Access Compliance Report

Public Rights-of-Way

(Pedestrian Signals)

Intersection ID: N/A	Main Street:	Cross Street: N/A	Location: N/A
ADA ID: 4435DEDDFC9F	Signal Type: Two Push Buttons-Non APS	Overall Compliance: No	Severity Score: BTN 1:N/A BTN 2: N/A No BTN: N/A
Codes/Mitigation Info/Possible Solution		Field Measurements/Component Compliance

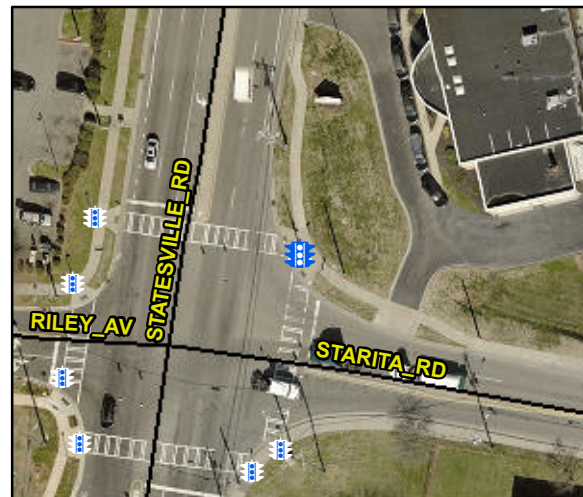
Possible Solutions: Replace Signal Push Button With APS Button on New Post. Remove & Relocate Sign.

PROW/ADA: TMUTCD 4e.08, R404.2, R404.3, R404.7.3

N/A	B 1 Clear Xing Direction?	Yes	N/A	B 2 Clear Xing Direction?	Yes
	B 1 Crossing Direction	To W		B 2 Crossing Direction	To S
Yes	B 1 DistanceTo XWalk (in)	56.0	Yes	B 2 DistanceTo XWalk (in)	12.0
No	B 1 DistanceTo Curb (in)	75.0	No	B 2 DistanceTo Curb (in)	75.0
Yes	B 1 Diameter (in)	2.0	Yes	B 2 Diameter (in)	2.0
